TE Connectivity

Product Change Notification: E-16-016427

PCN Date: 07-FEB-17

General Product Description:
AMPMODU SYSTEM 50 SINGLE AND DOUBLE ROW RECEPTACLE HOUSINGS AND ASSEMBLIES.

147378 AND 104550 Assembly Changes:

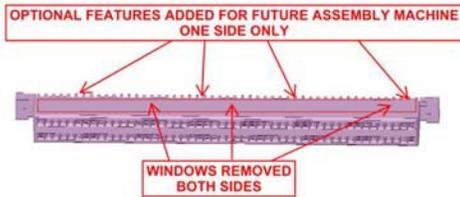
STANDARDIZATION OF REPLACEMENT TOOLING AS CURRENT TOOLS ARE WORN. 1. MATERIAL CHANGE FROM ZENITE LCP TO MORE READILY AVAILABLE AND TE PREFERRED SUMIKASUPER LCP. 2. REMOVED WINDOWS ON SIDE OF PART FOR BOTH VERTICAL AND HORIZONTAL HOUSINGS. 3. REMOVED CORNER CHAMFERS ON VERTICAL HOUSINGS. 4. ADDED OPTIONAL FEATURES (NOTCHES) ON ONE SIDE OF HOUSINGS TO ALLOW FOR USE IN FUTURE ASSEMBLY MACHINE.
